APPLICATION FOR SOIL INVESTIGATION

SOIL INVESTIGATION REPORT

SOIL INVESTIGATION REPORT
INDIVIDUAL SEPTIC TANK SYSTEM
WITH SUBSURFACE,
SOIL ABSORPTION,
EFFLUENT DISCHARGE

DIAGRAM OF PROPERTY

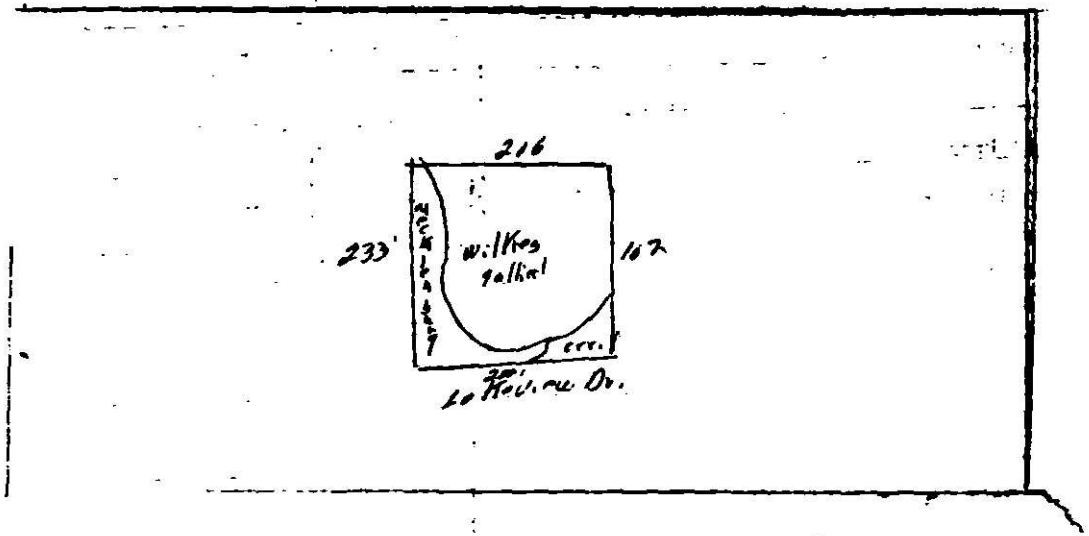
Recommendations Removed. Based on this investigation, ~~there~~ there is not an adequate area of provisionally suitable soil on the lot for the installation of a septic tank system.

See Diagram on back
